Access Compliance Report

Public Rights-of-Way

Intersection ID: 25538	Main Street: HATTON_CROSS_DR	Cross Street: KENSAL_GREEN_DR	Location: SE
ADA ID: 1CE42679692A	Ramp Type: PerpDiag	Initial Pass/Fail: Fail	Overall Compliance: No
		Severity Score: 35

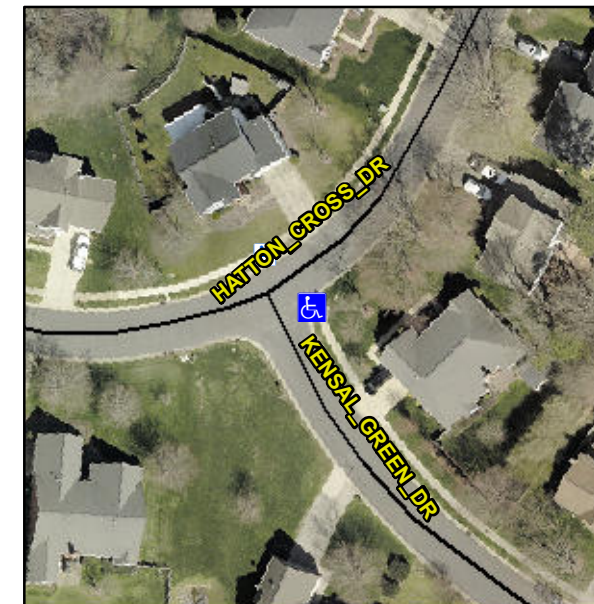
Not Found, R304.5.1

Compliance	Description	Data	Compliance	Description	Data
N/A	Ramp Length (in)	97.0	Yes	Ramp Slope (%)	5.7
No	Ramp Width (in)	28.3	Yes	Ramp XSlope (%)	0.9
N/A	Flare Type LT	N/A	N/A	Flare Type RT	N/A
N/A	Flare Slope LT (%)	N/A	N/A	Flare Slope RT (%)	N/A
N/A	Flare Traversable LT?	N/A	N/A	Flare Traversable RT?	N/A
N/A	Landing Length (in)	N/A	N/A	DWS Provided?	N/A
N/A	Landing Width (in)	N/A	N/A	DWS Contrast?	N/A
N/A	Landing Slope (%)	N/A	N/A	DWS Length (in)	N/A
N/A	Landing X Slope (%)	N/A	N/A	DWS Full Width?	N/A
N/A	Landing Curb? (Y/N)	N/A	N/A	DWS Offset (in)	N/A
N/A	Shared Landing?	N/A			
N/A	Gutter Ponding?	N/A	N/A	Gutter Slope (%)	N/A
N/A	Gutter Lip Ht (in)	N/A	N/A	Gutter X Slope (%)	N/A
N/A	Painted X Walk1?	No	N/A	Painted X Walk2?	No
	X Walk 1 Direction	To NW		X Walk 2 Direction	To SW
N/A	X Walk 1 Width (in)	N/A	N/A	X Walk 2 Width (in)	N/A
	X Walk 1 Slope (%)	1.2		X Walk 2 Slope (%)	1.0
	X Walk 1 X Slope (%)	0.5		X Walk 2 X Slope (%)	0.6

Remove & Replace Curb Ramp With Two New Directional Ramps or Equivalent.
